SHELIA BLOXTON FAMILY DIVISION SUBDIVISION

APPLICATION NUMBER 8 DATE December 3, 2015

DETAIL SITE PLAN

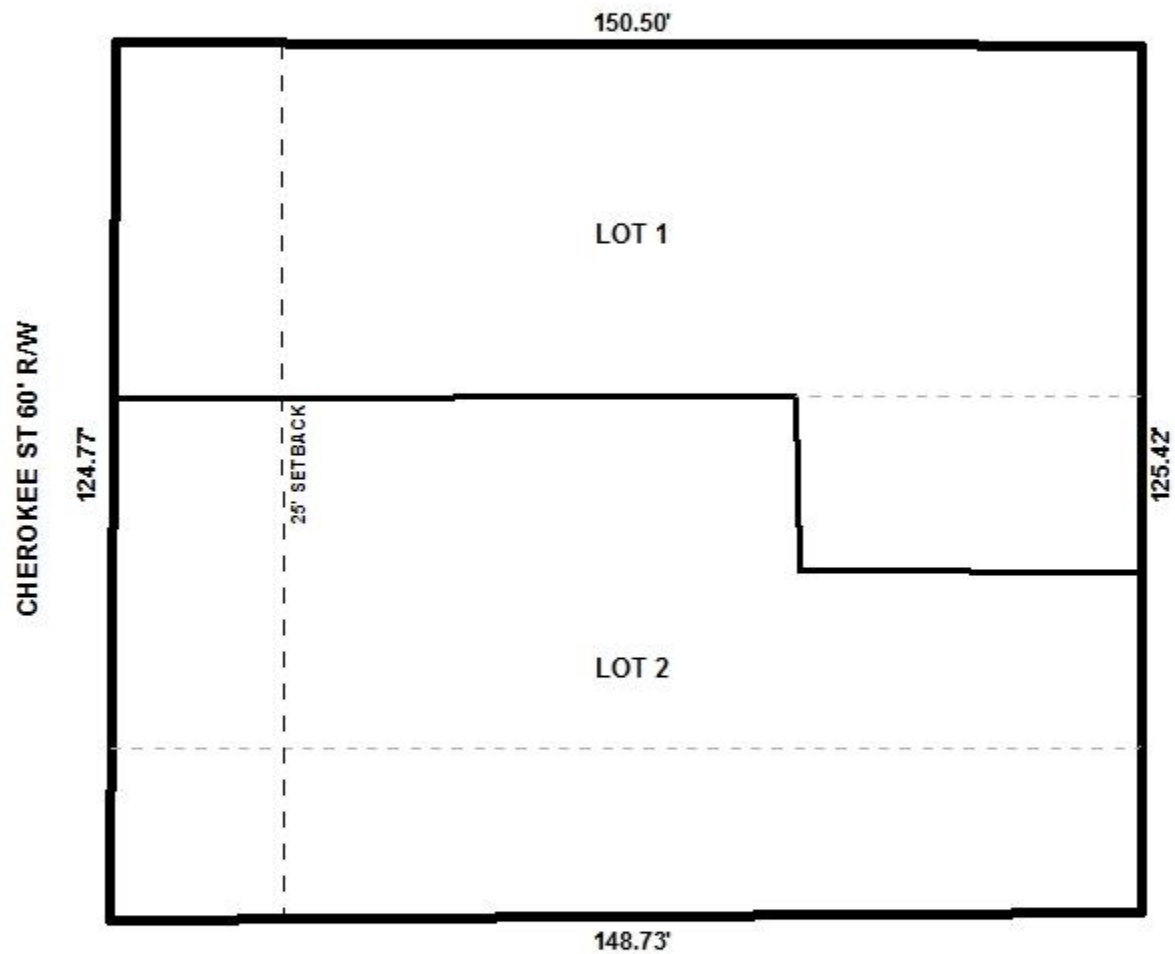
As proposed, the relocation of the common interior property line would create a Zoning Ordinance violation in that it would run along the back edge of the existing garage on proposed Lot 2 on the North-South run and not meet the required 8' rear setback. And the East-West run would be only 3.02' off the edge of the existing sunroom on proposed Lot 1 and would not meet the required 8' minimum side yard setback. No justification was submitted that would support a deviation from side and rear setbacks required by the Zoning Ordinance, and no Planned Unit Development or Variance was submitted for such.

- 1) the proposed North-South run in the common interior property line would create a violation of the 8' rear setback requirement of the Zoning Ordinance;
- 2) the proposed East-West run in the common interior property line would create a violation of the 8' side yard setback requirement of the Zoning Ordinance; and
- 3) no justification was submitted supporting the deviation from side and rear setbacks required by the Zoning Ordinance, and no Planned Unit Development or Variance was submitted to allow reduced setbacks.
